IN THE MATTER of Proposed Plan Change 92 to the
Western Bay of Plenty District Plan
First Review - Ōmokoroa and Te
Puke Enabling Housing Supply and
Other Supporting Matters

WESTERN BAY OF PLENTY DISTRICT COUNCIL PLANNING REPLY

Date: 29 September 2023

Figure 1: Plan Change 92 – Notified District Plan Maps

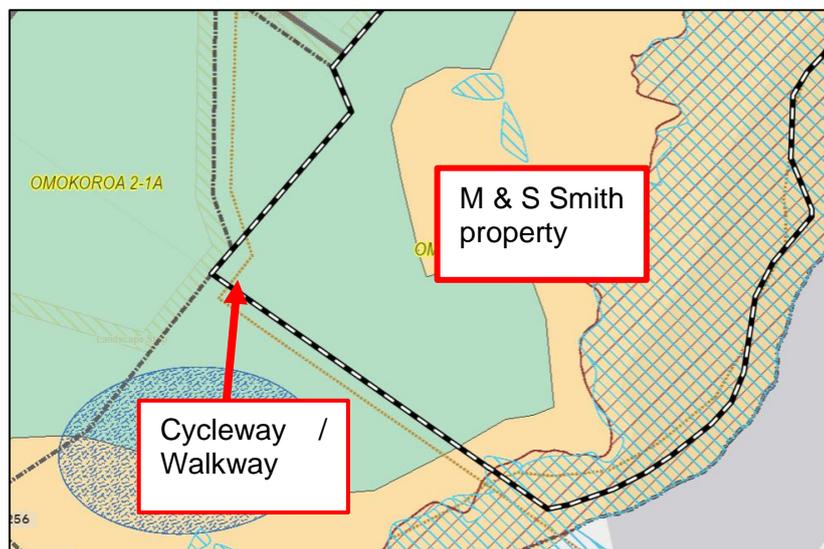
107. Mike and Sandra Smith made submissions on Plan Change 92, which amongst other things, requested a change to the walkway/cycleway shown on the Ōmokoroa Structure Plan where it crosses their boundary. The cycleway as notified is shown below (yellow line) in Figure 1.

Figure 2: S42A Report Recommended Change

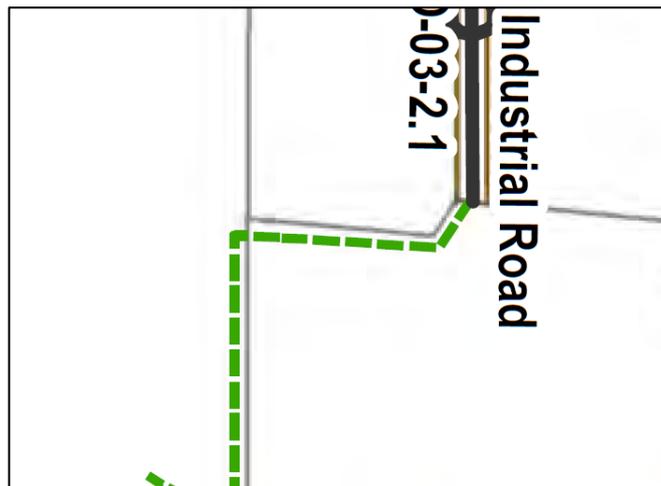
108. The Section 42A Report recommended the alignment of the cycleway be changed such that it be wholly contained in the submitter's property, on the basis that this will align with a future road within the submitter's property which is to be formed via subdivision and development. The recommended change is shown in Figure 2 below.

Figure 3: Supported Changes (refer green line) shown over Waka Kotahi Plans

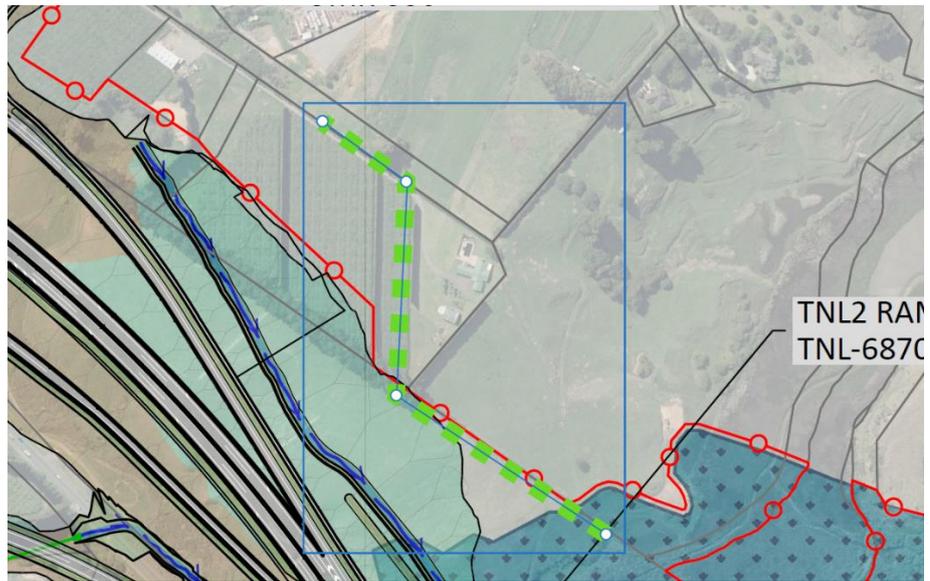
109. The submitter remains unsatisfied by the change and I have revisited the submissions, considered the Waka Kotahi possible SH2 realignment and designation design information presented at the Plan Change 92 hearing with the submitter and have undertaken a further site visit. In considering this information, both the submitter and myself have agreed to support a further change as shown in Figures 3 and 4 below, on the basis that:

- The alignment is consistent with the notified version of the structure plan and the affected landowner (at 491 Ōmokoroa Road) did not submit against the proposed cycleway within their property;

- The alignment is mostly beyond the intended SH2 designation and sites wholly outside of the submitters property;
 - The alignment will connect with the eastern extent of Council's planned industrial road project, which includes a walkway/cycleway to this point.

STATUS PRELIMINARY	
DATE 09.02.2023	SCALE (ORIGINAL SIZE A3) 1:4000
DRAWING NUMBER 144702-00-0755	REVISION A

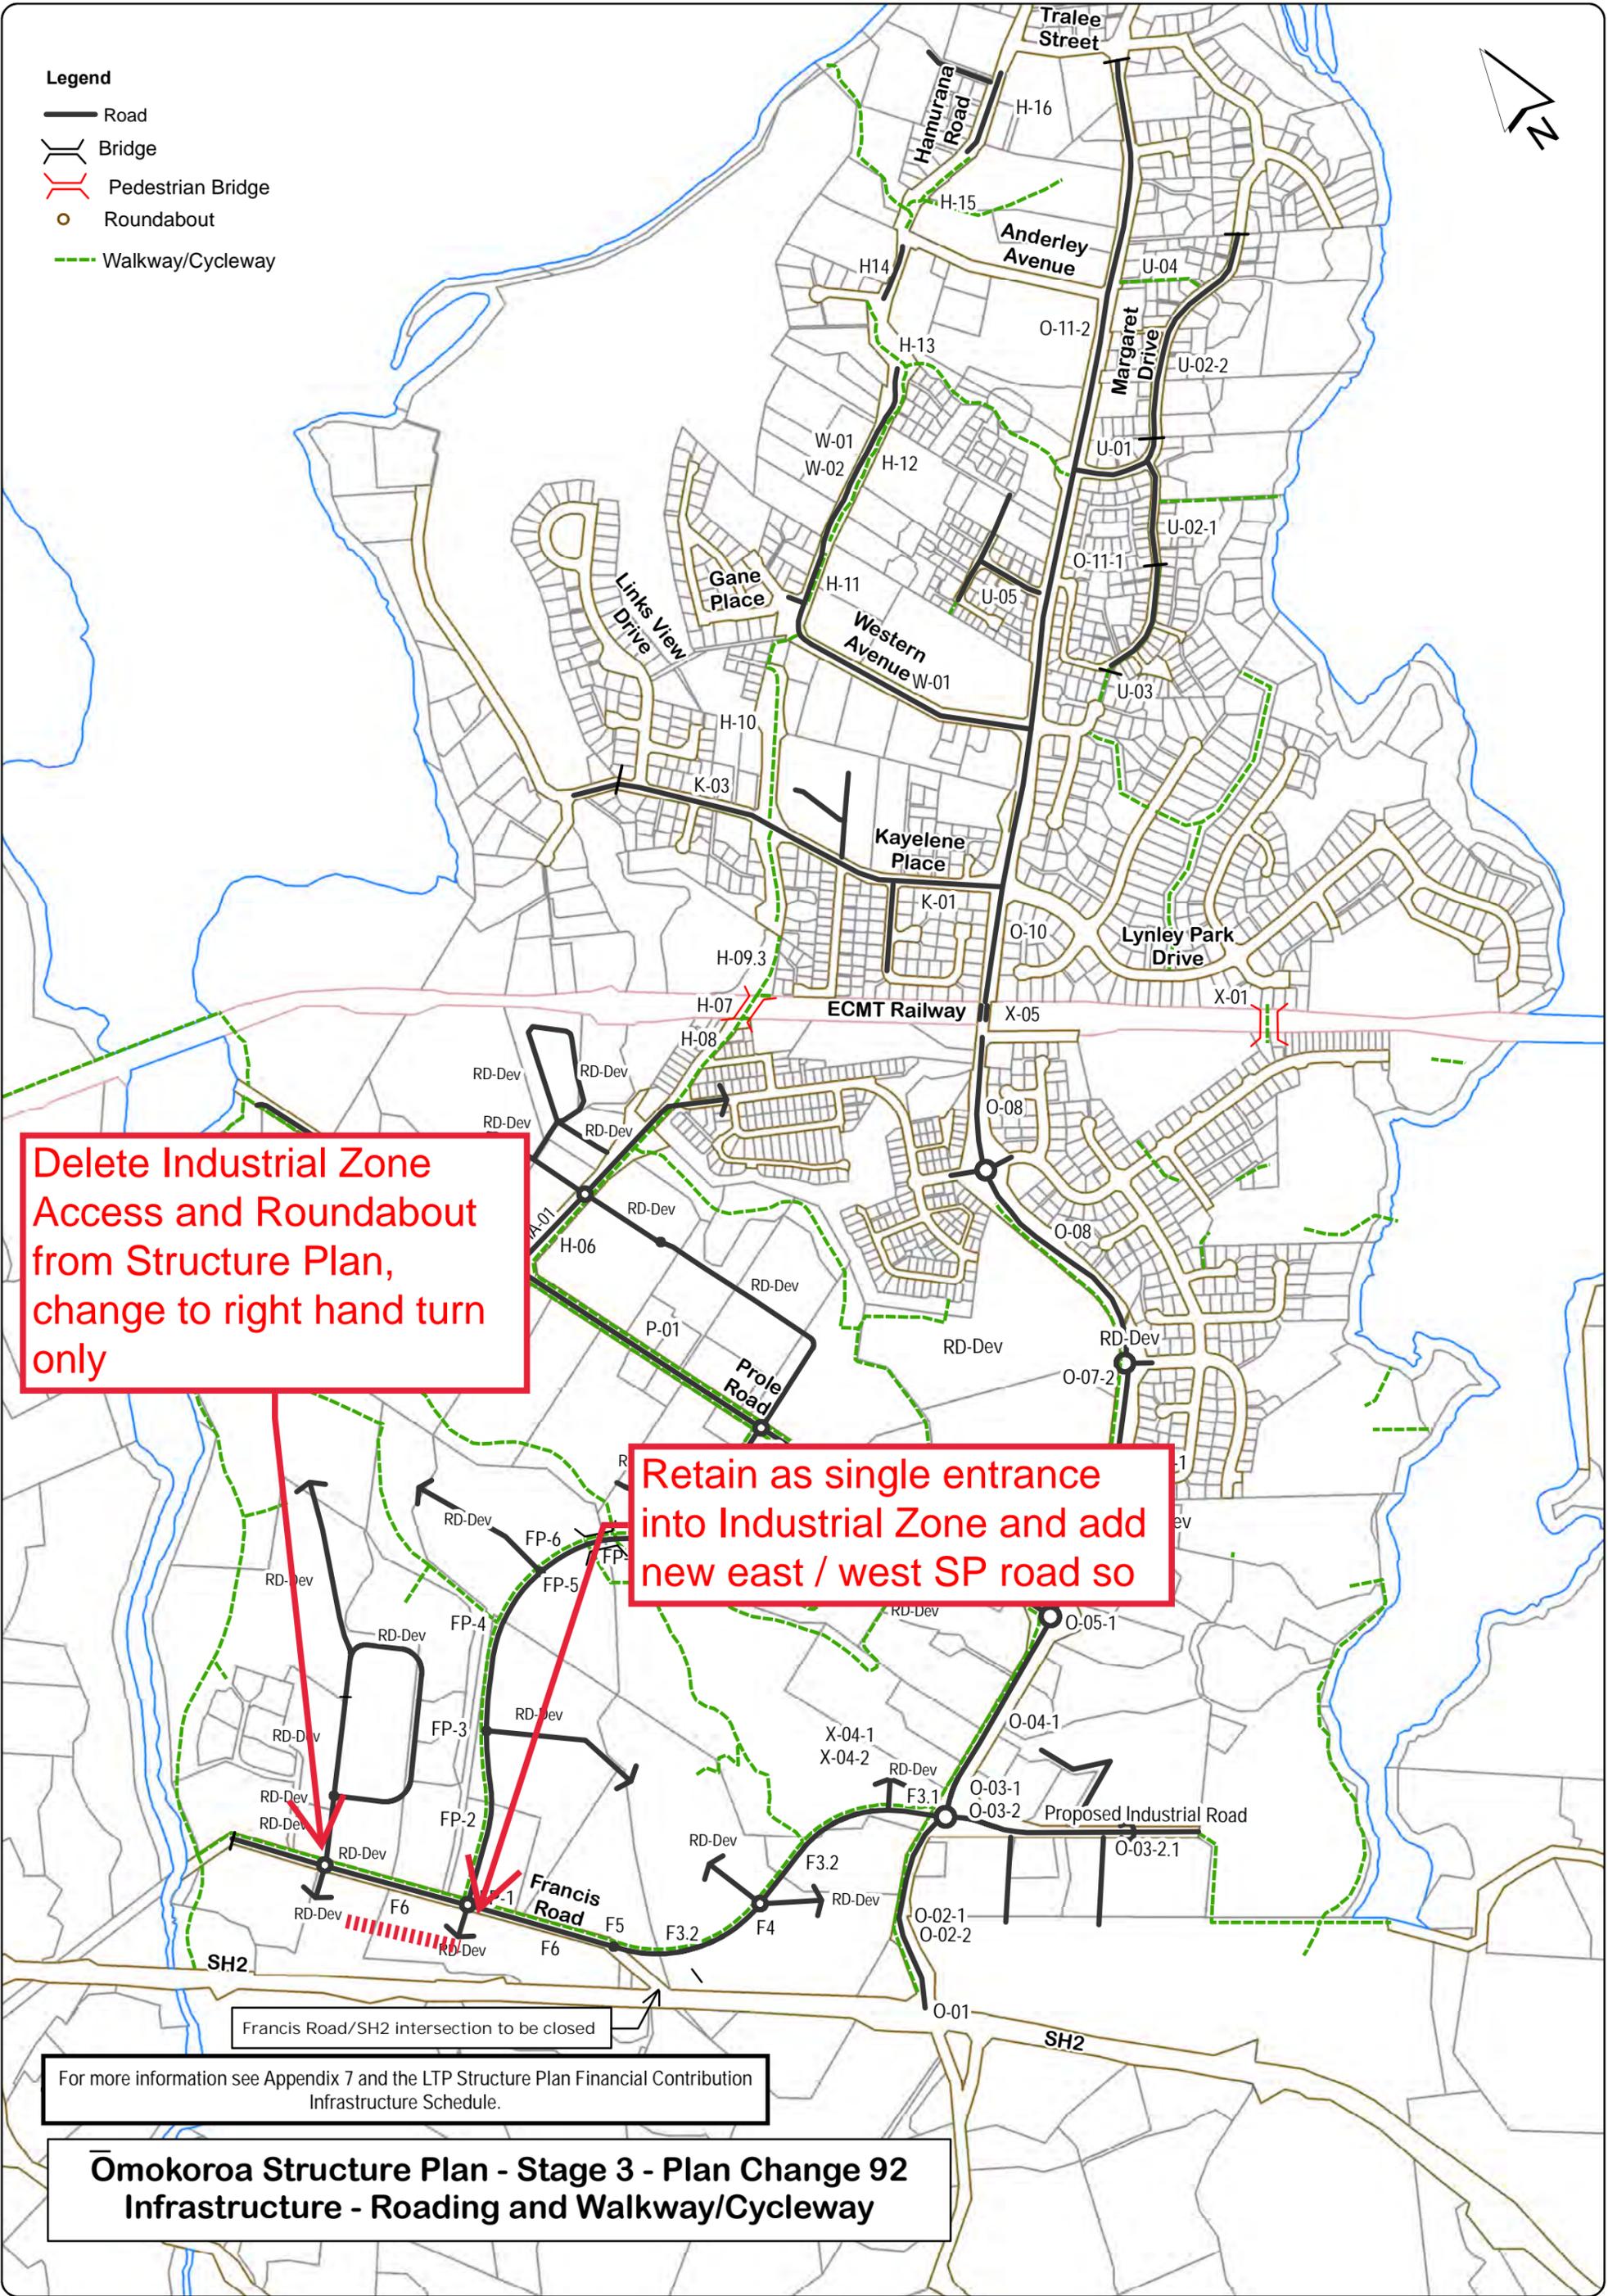
116. Taking note of the submissions from Mr Bagley, Mr Prout, Mr Hicks and Ms Hicks, in our opinion further refinement of the structure plan may assist the submitters. This includes:

- (a) Deletion of the western roundabout from the Structure Plan and change this to a right turn bay. This would preclude industrial land using the western roundabout as an access point.

- (b) Retain the roundabout which connects with the Prole/Francis link road as the single entry to the Industrial Zone. The location of this roundabout is an efficient transport outcome given it connects to other primary structure plan roads.

- (c) Add a new east/west Industrial Zone structure plan road. This would ensure access is available to 51 Francis Road, being one of two proposed industrial zoned properties at the western end of Francis Road.

Delete Industrial Zone Access and Roundabout from Structure Plan, change to right hand turn only
